**PLANNING AND DEVELOPMENT SERVICES STAFF REPORT**

**For Planning Commission Meeting of December 17, 2013**

**SUBJECT: 624 Church Street Site Plan for City Council Approval  
(624 Church Street)  
File No. SP13-049**

### 624 Church Street Summary Report

1st Floor Plan with Site Plan

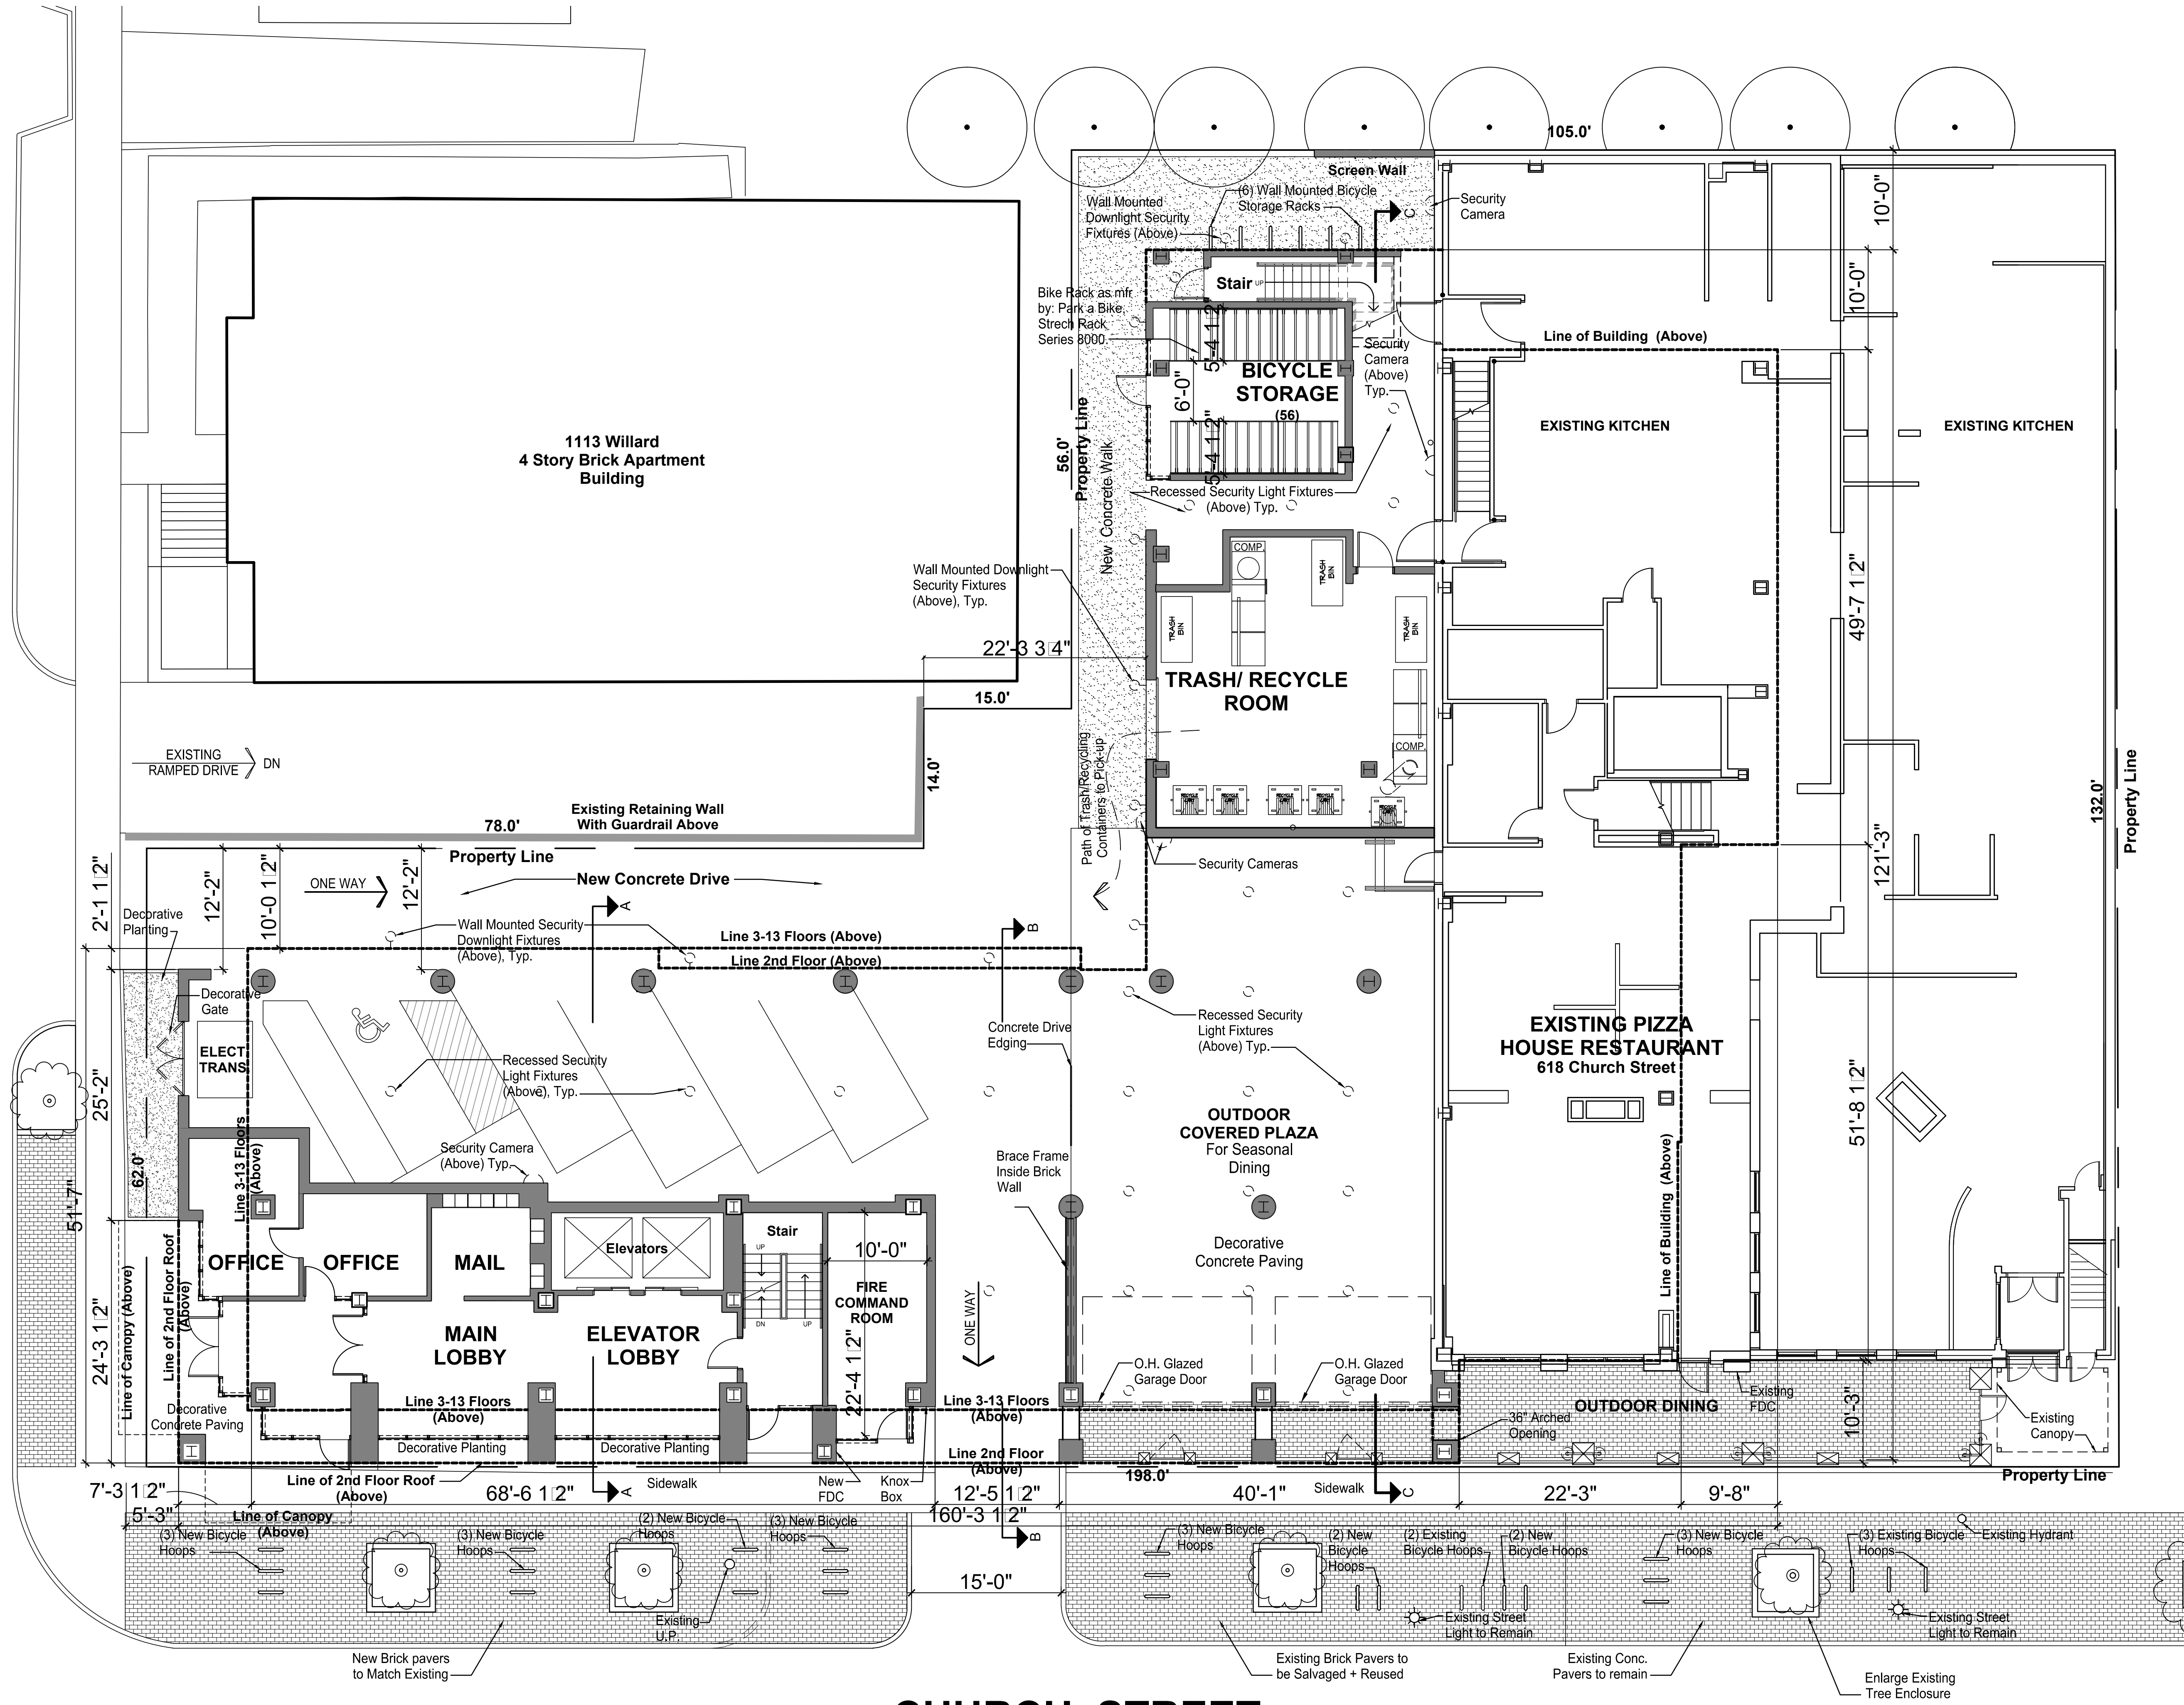
The Board also encouraged the petitioner to reconsider the location of the bicycle parking and ensure adequate visibility for pedestrians and motorists exiting the drive on site. However, the bicycle parking was not adjusted and remains in the same location as originally designed. The petitioner has provided the attached statement of revisions in response to the Board's report.

Planning staff has concerns regarding the location of the bicycle parking room. Echoing concerns of the Design Review Board, and based on the observations of bicycle parking rooms in similar downtown projects staff recommended that the room be moved closer to the front of the building. The location of the room as proposed will require the petitioner actively promote this area to ensure usage. In addition, it appears the area previously designated as an outdoor plaza will be used solely for outdoor dining. While this is an allowable use and will activate that space along the street, it is a change from the open plaza use presented at the Design Review Board.
